Rezoning Transportation Analysis

Petition Number: 2019-180

General Review Information

Transportation Summary

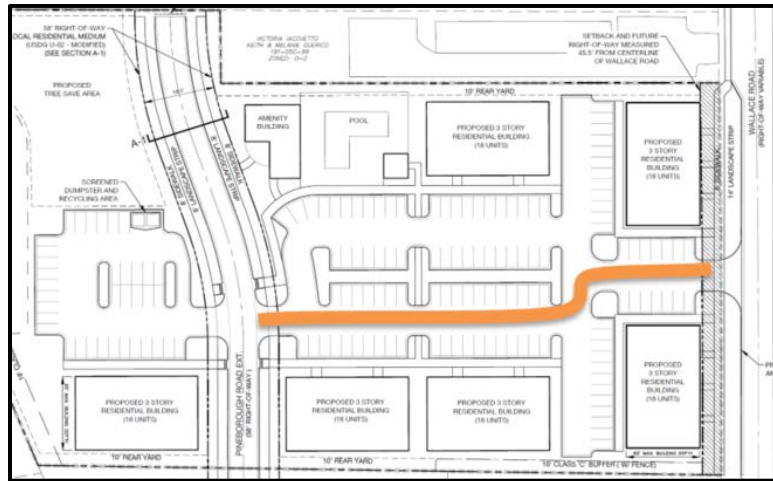
4. ~~In accordance to the council adopted Urban Street Design Guidelines, the petitioner should revise the site plan and conditional note(s) to commit to construct a public street to connect Pineborough Road extension and Wallace Road. The cross section should include an 8-foot planting strip, and 8-foot sidewalk due to the proposed density of 22 DUA to comply with Chapter 20 Subdivision ordinance.~~
 - a. ~~Technical Correction (02-10-2020) The site plan should commit to constructing a private street connection between Pineborough Road to Wallace Road to improve street connectivity, similar to what was done for rezoning petition 2019-074.~~
